COVER SHEET
SANITARY SEWER PLANS

WOODSIDE RIDGE
FIRST PLAT

LEE'S SUMMIT, MO

AS BUILT
Date Surveyed: 04-20-2020

SHEET
C208

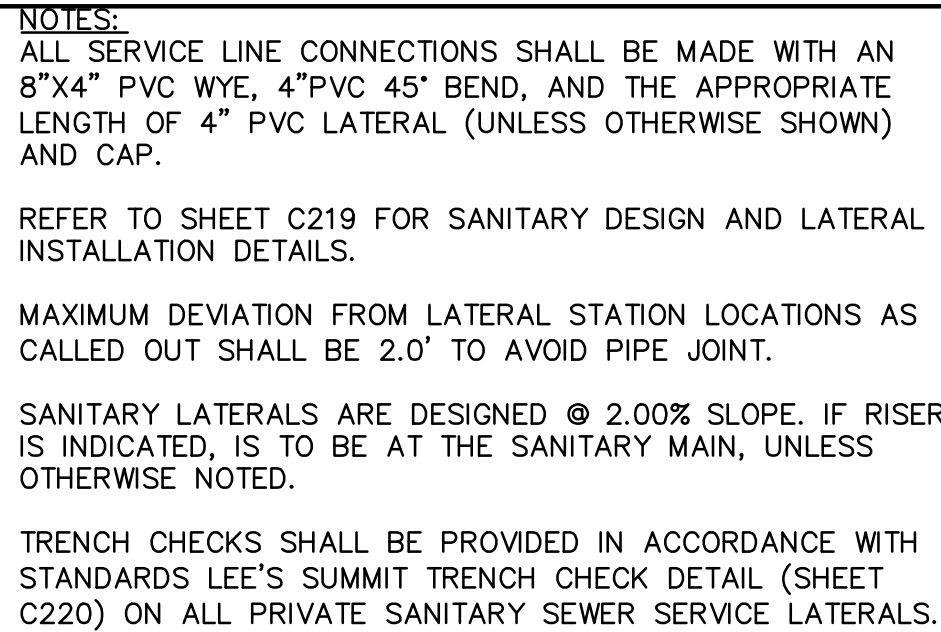
As-built is 1.11' N and 0.12' W of plan

M.H. #1-13, CONST. STD.
SANITARY MANHOLE (4' DIA. INSIDE)
STA.: ~~34+35.32~~ (SANITARY LINE 1)
=STA.: ~~35+24.81~~ (C) **35+25.53** **36.11'**
NW AMBERSHAM DRIVE, ~~36.84'~~ RT

SHEET C211

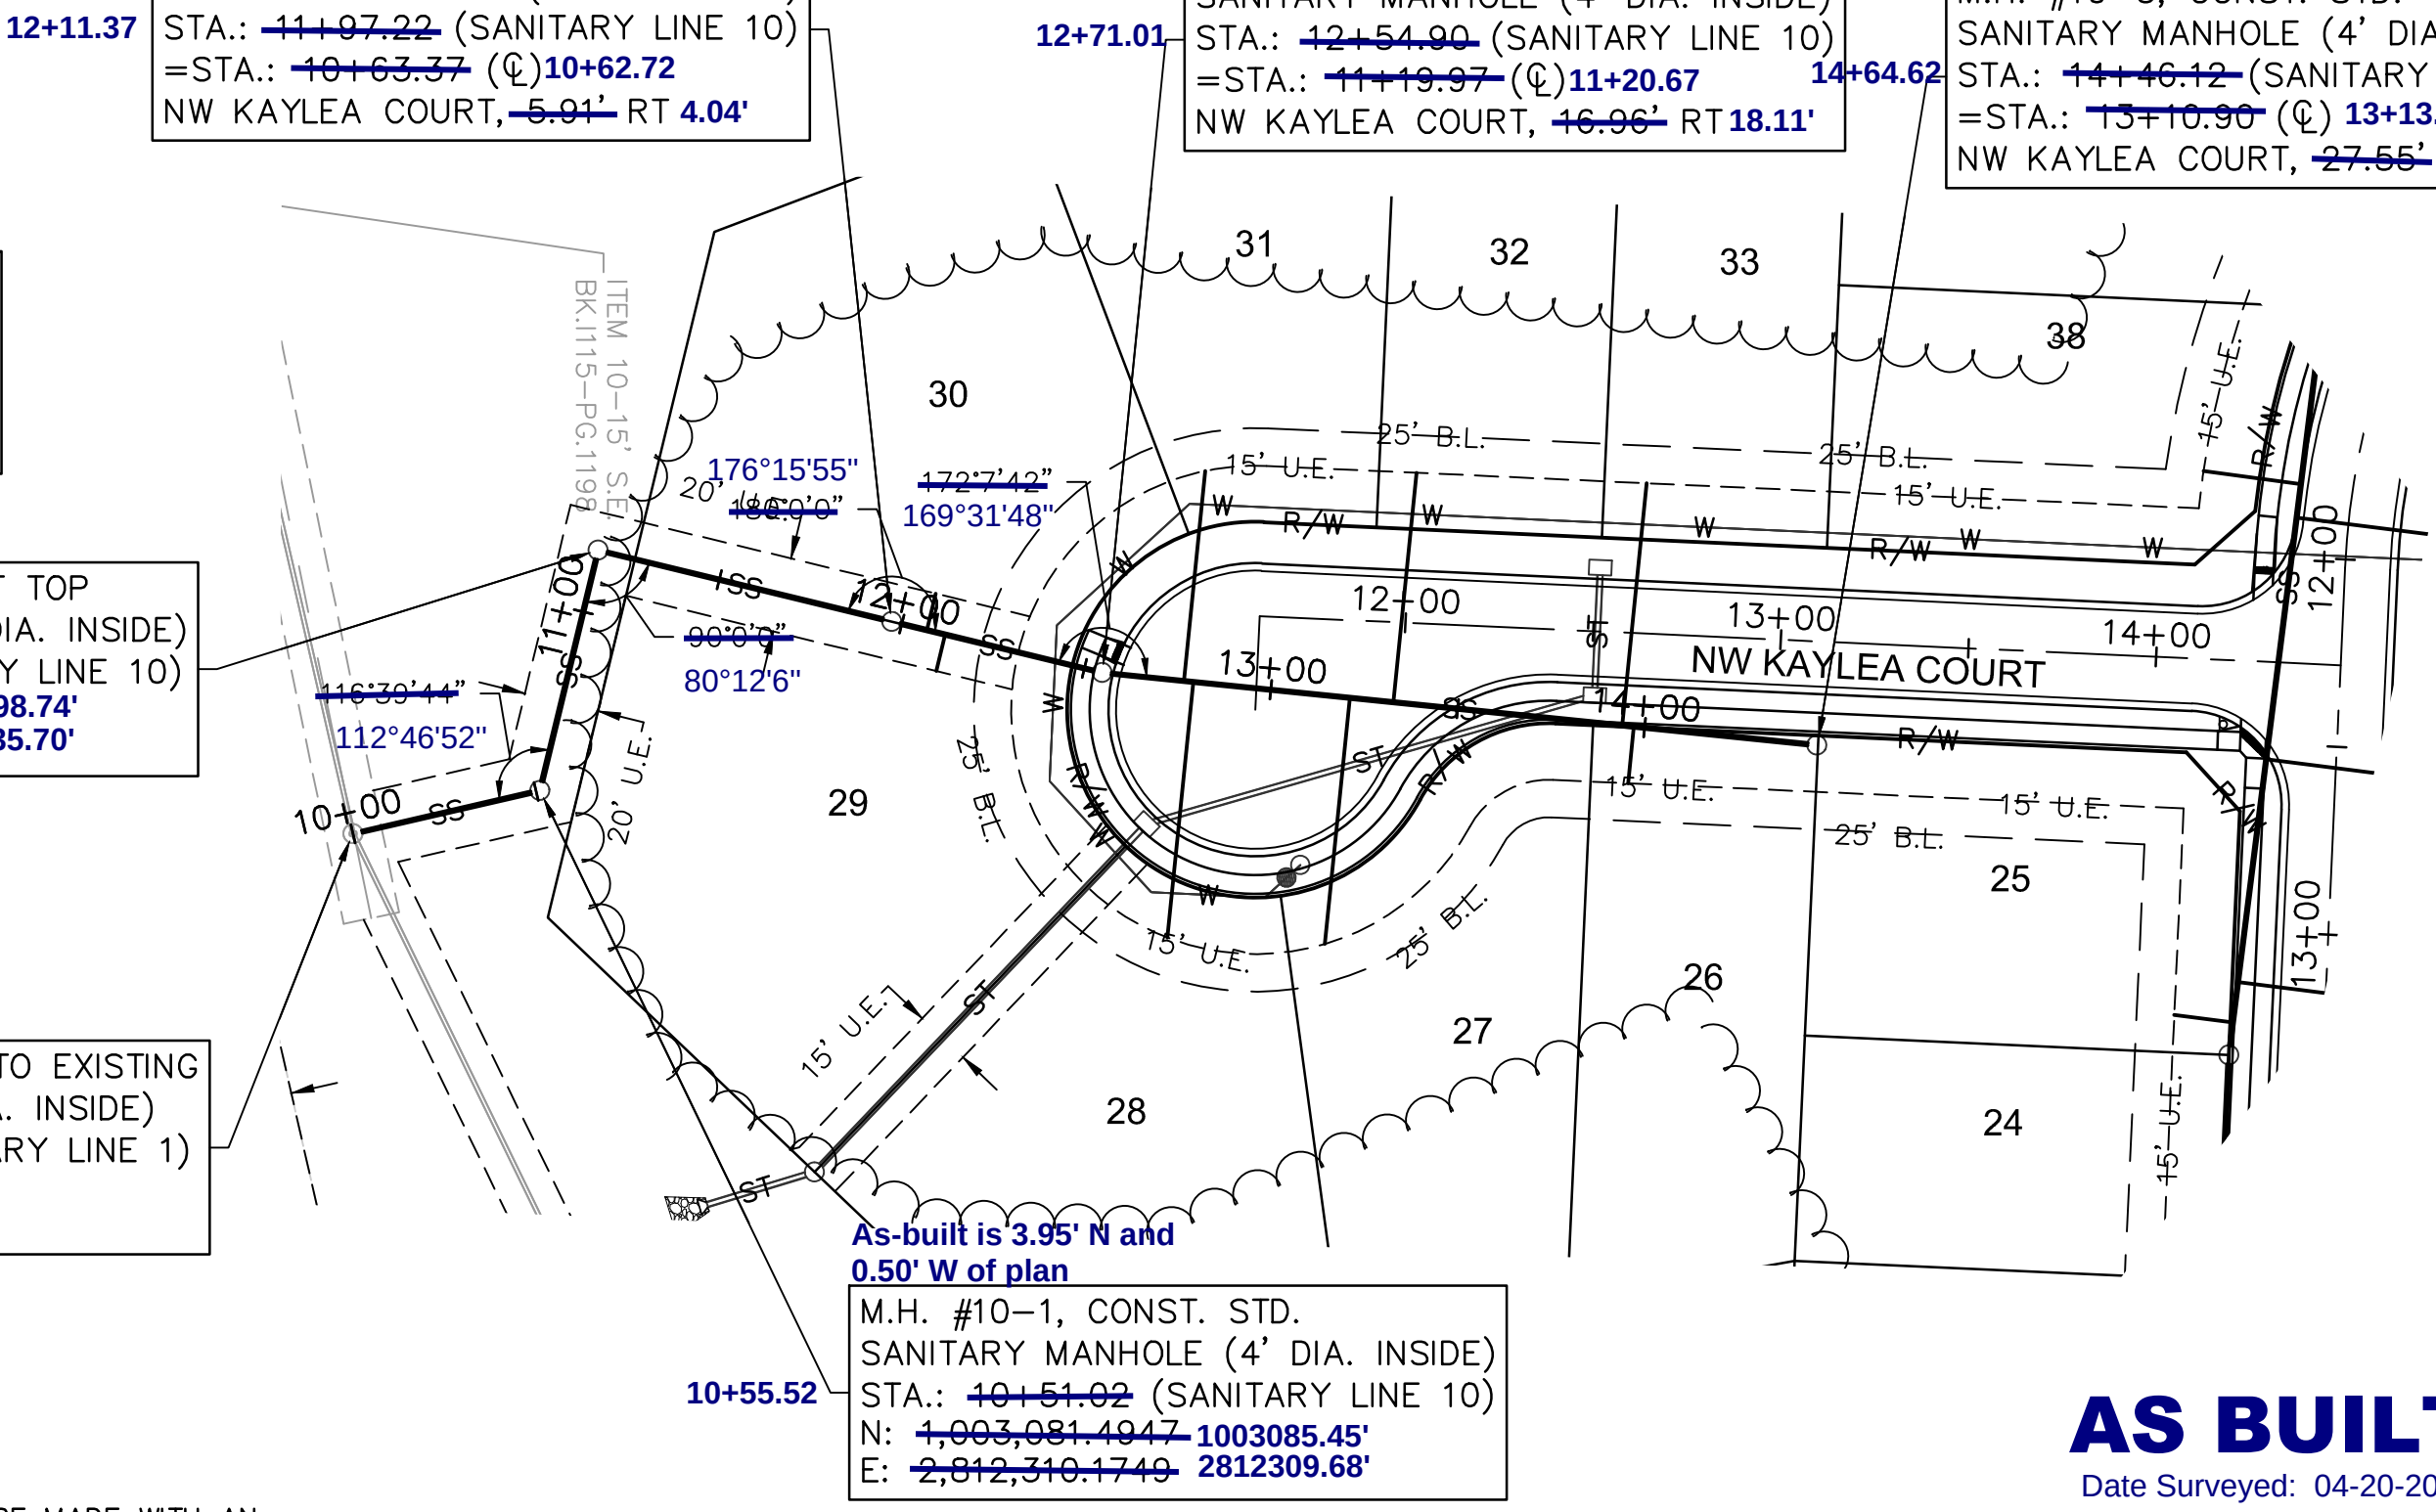
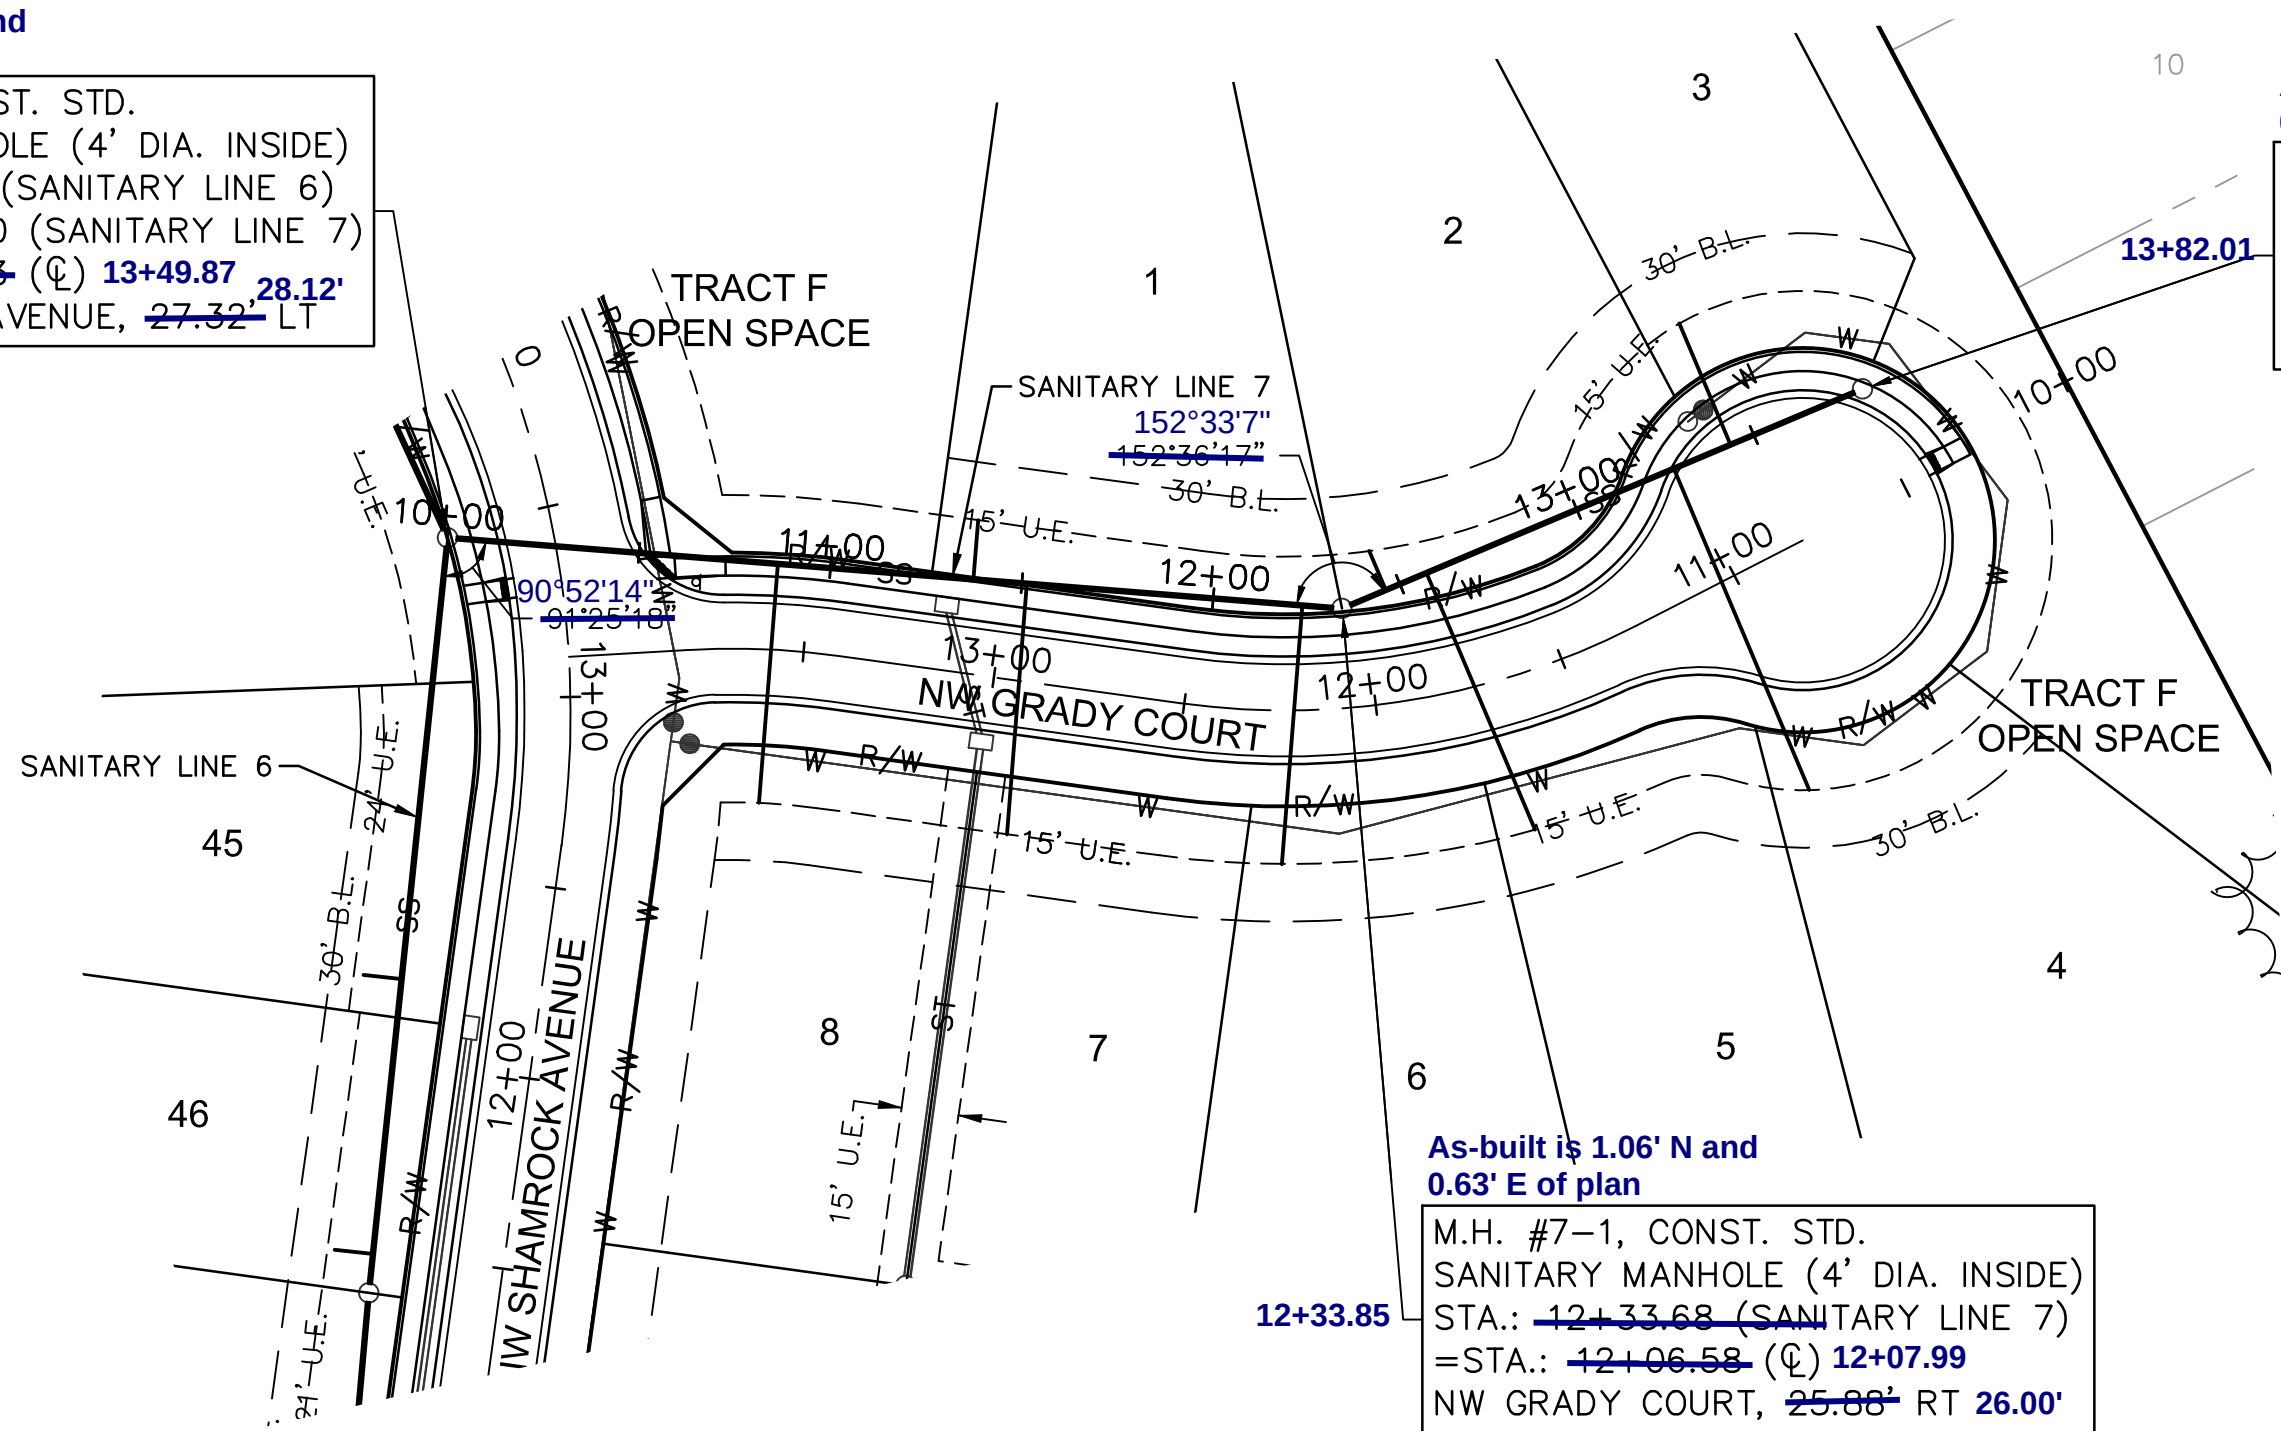
As-built is 0.09' N and
2.31' E of plan
M.H. #6-2, CONST. STD.
SANITARY MANHOLE (4' DIA. INSIDE)
STA.: ~~13+62.30~~ (SANITARY LINE 6)
=STA.: 10+00.00 (SANITARY LINE 7)
=STA.: ~~13+47.43~~ (C) ~~13+49.87~~ ~~28.12'~~
NW SHAMROCK AVENUE, ~~27.32'~~ LT

As-built is 0.14' N and
0.58' W of plan
M.H. #7-2, CONST. STD.
SANITARY MANHOLE (4' DIA. INSIDE)
STA.: ~~13+80.79~~ (SANITARY LINE 7)
=STA.: ~~10+48.14~~ (C) ~~10+48.25~~
NW GRADY COURT, ~~28.66'~~ RT ~~27.42'~~

As-built is 1.71' N and
10.51' W of plan
M.H. #10-2, CONST. FLAT TOP
SANITARY MANHOLE (4' DIA. INSIDE)
STA.: ~~11+16.84~~ (SANITARY LINE 10)
N: ~~1,003,097.0286~~ ~~1003098.74'~~
E: ~~2,812,246.2060~~ ~~2812235.70'~~
